Re: Harbor Grove Submittal Review Comments

We have finished reviewing the Harbor Grove submittal package per your request, following are our review comments for your information, review, and distribution to the applicant.

- Civil Plan Set for Harbor Grove, prepared by The Blueline Group, dated 8/9/22.
- Storm Drainage Report for Harbor Grove, prepared by The Blueline Group, Date: May 3rd, 2022 and Revision Date: August 9th, 2022.
- Geotechnical Engineering Study for "Daffron Property", prepared by Earth Solutions NW, LLC, dated July 30, 2021 and Updated July 28, 2022.
- Groundwater Elevation Evaluation for "Proposed Development", prepared by Cobalt Geosciences, dated March 14, 2022.
- Stormwater Pollution Prevention Plan (SWPPP) for Harbor Grove, prepared by The Blueline Group, dated 08/09/2022.
- Revised Critical Area Reconnaissance Report for Sea Pac Homes, prepared by Wetland Resources, dated December 9, 2021.

SHT **15** OF **21**

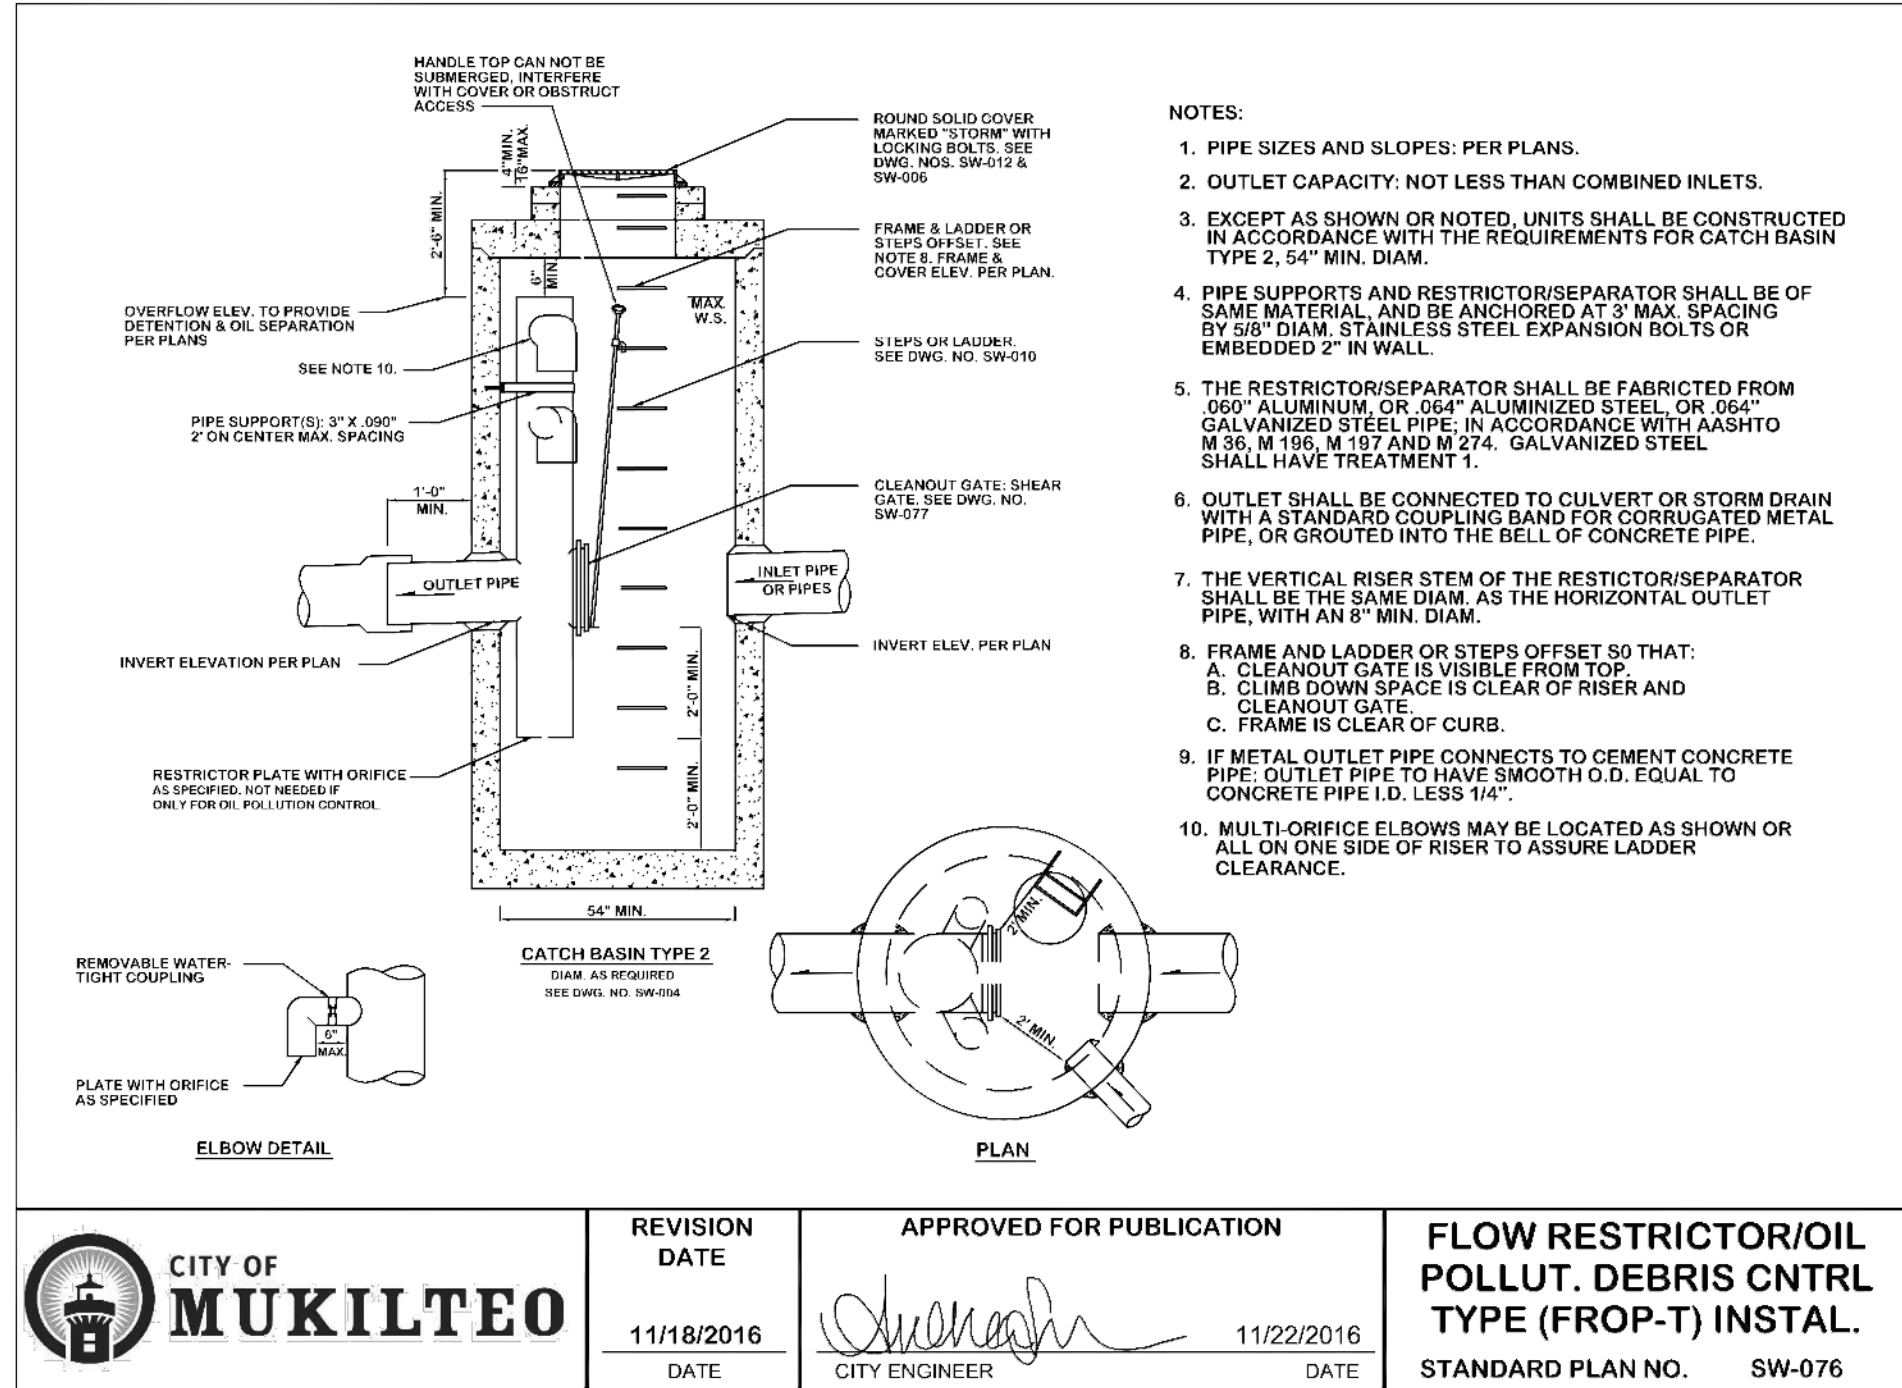
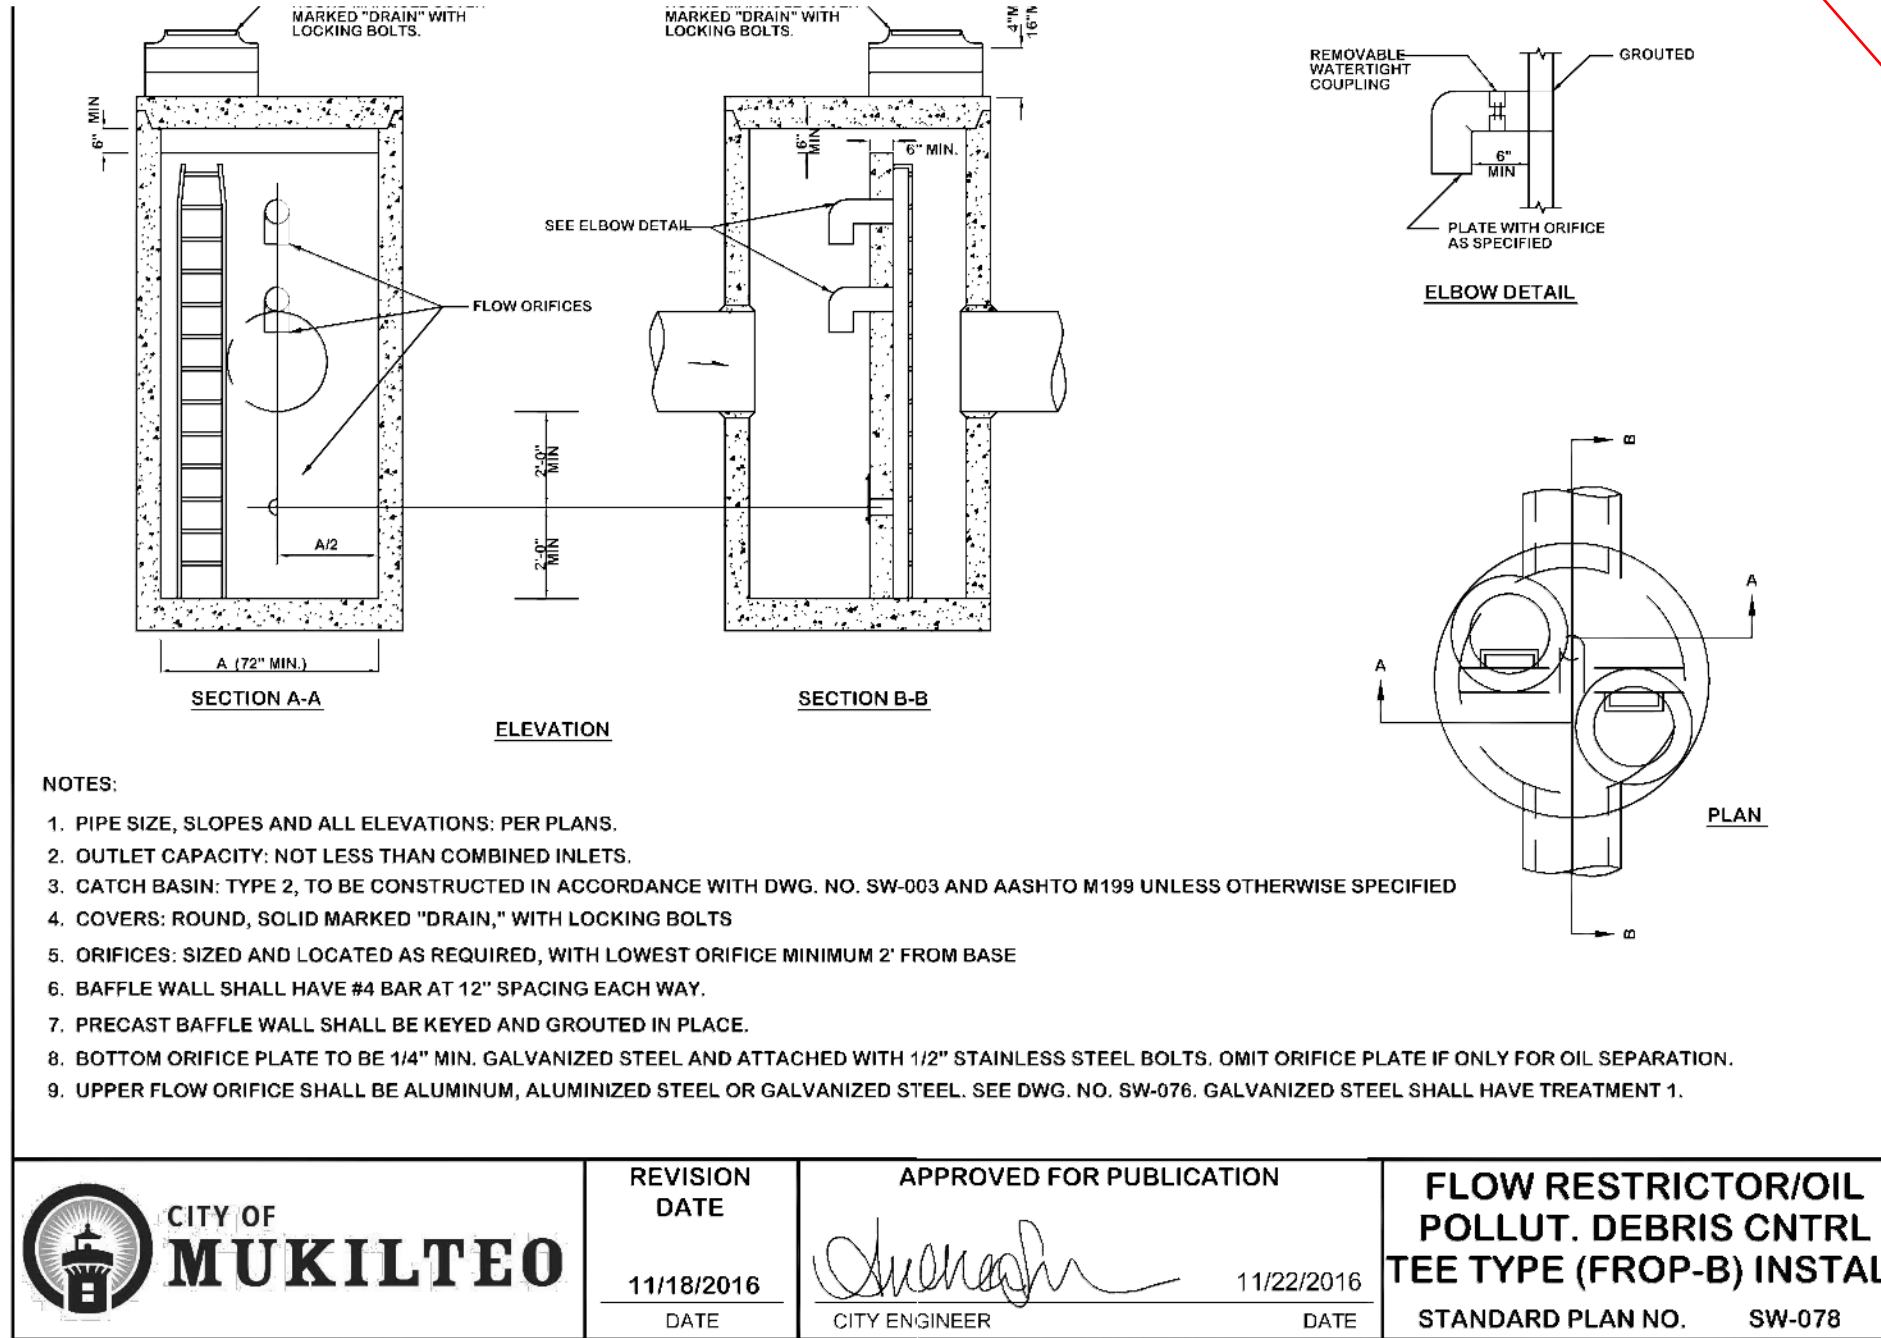
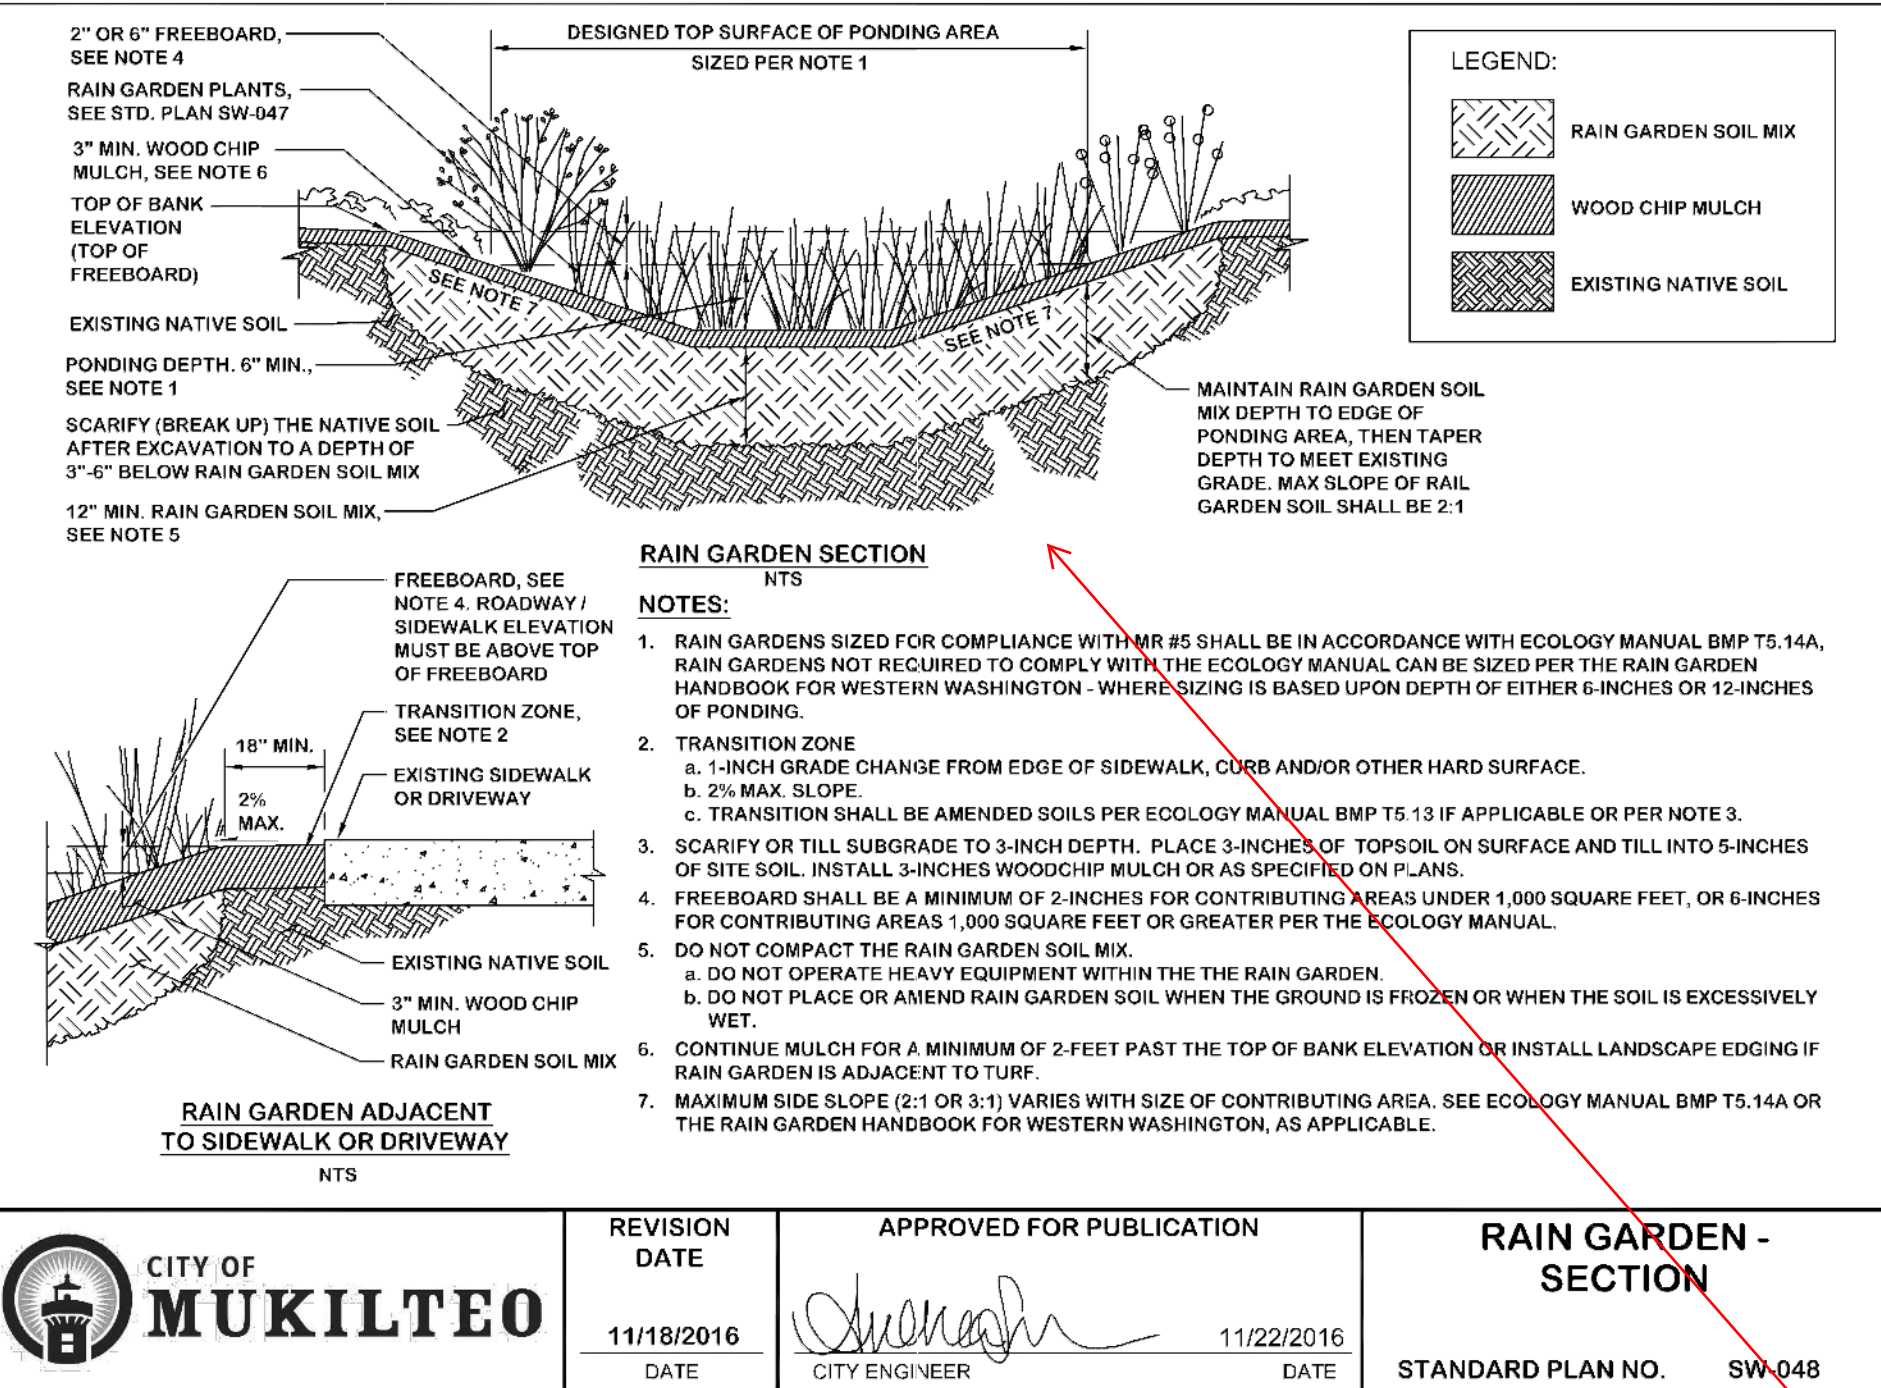
1. Applicant shall address the concerns expressed in the September 27, 2022 letter from Rugosa Ridge Homeowner's Association.

2. CB 9 detail shows “inlet from CB 9”. This should be “inlet from CB 10” from the pump structure.
3. Please address how the pump system is accessed for inspection and maintenance, and clearly note ownership/operation/maintenance responsibilities on this sheet.
4. Specify how the pump line can be serviced, repaired, or replaced under the walls when it becomes necessary.

Applicant shall address the concerns expressed in the September 27, 2022 letter from Rugosa Ridge Homeowner's Association.
